Appendix M
Road Safety Audits

Clongriffin to City Centre CBC

City Centre to Kimmage CBC

Road Safety Audit Stage 1

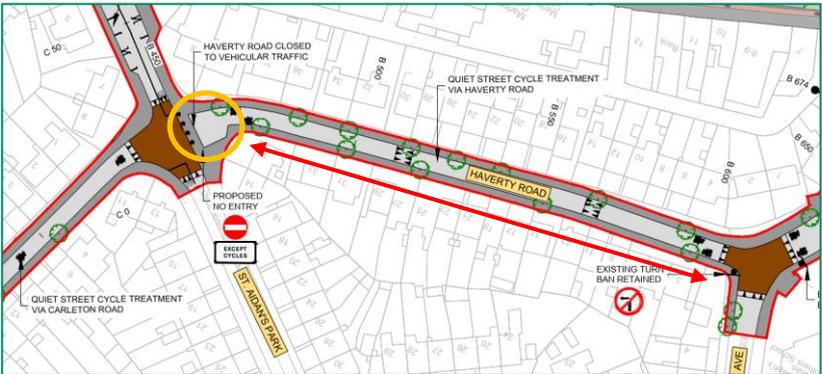
4.3.18 Problem	
<i>Location:</i>	Malahide Road / Brian Road junction
<i>Drawing:</i>	Sheet 20 of 21
<i>Summary:</i>	Unclear where vehicles are to stop when pedestrian crossing activated
Description:	
 <p>The diagram shows a road junction with Malahide Road on the left and Brian Road on the right. Malahide Road has a bus lane (pink) and a general traffic lane (grey). Brian Road has a bus lane (blue) and a general traffic lane (grey). A pedestrian crossing is shown on Brian Road, with a yellow zebra crossing. A red line indicates the proposed pedestrian crossing location on the northern side of Brian Road. A 'STOP' sign is shown at the junction. A yellow dashed line indicates the current stop line for northbound traffic on Brian Road, which is located before the pedestrian crossing. A red dashed line indicates the proposed stop line for northbound traffic on Brian Road, which is located after the pedestrian crossing. The diagram highlights the lack of a stop line for northbound traffic at the proposed pedestrian crossing location.</p> <p>Figure 4.24 – Lack of Stop Line</p>

<p>It is proposed to move the pedestrian crossing from the southern side of Brian Road to the northern side. It is unclear where vehicles are to stop when the crossing is called for traffic travelling northbound. This could confuse drivers resulting in a rear end shunt collision.</p>	
Recommendation:	
<p>A 'STOP' line (RRM 017) should be provided at an appropriate location.</p>

Figure 4.27 – Kilmore Road Junction

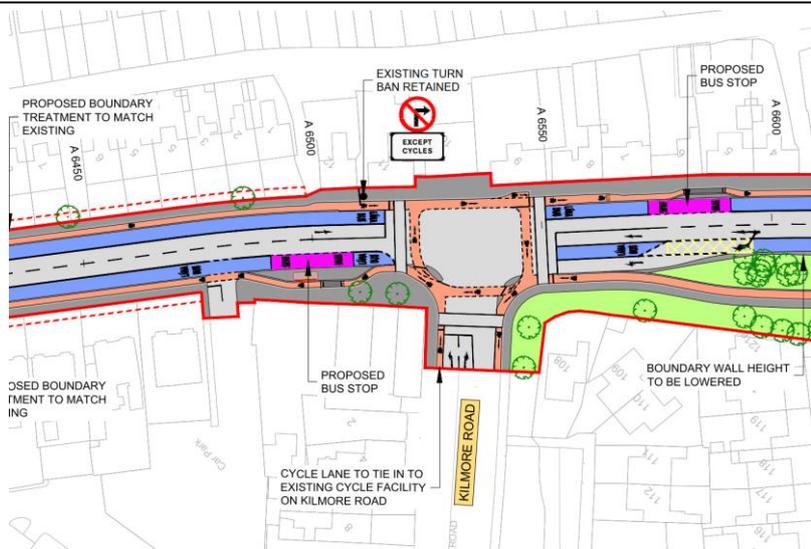
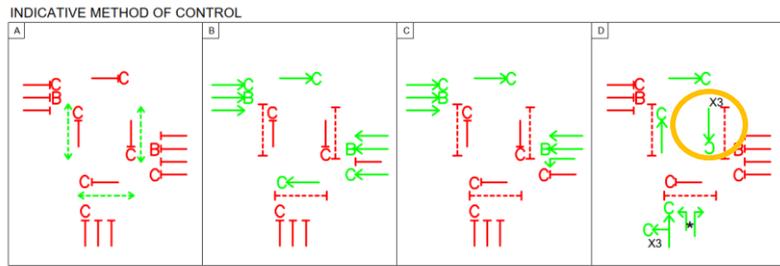
4.3.20 Problem	
Location:	Kilmore Road Junction
Drawing:	Sheet 15 of 21
Summary:	Signal Staging
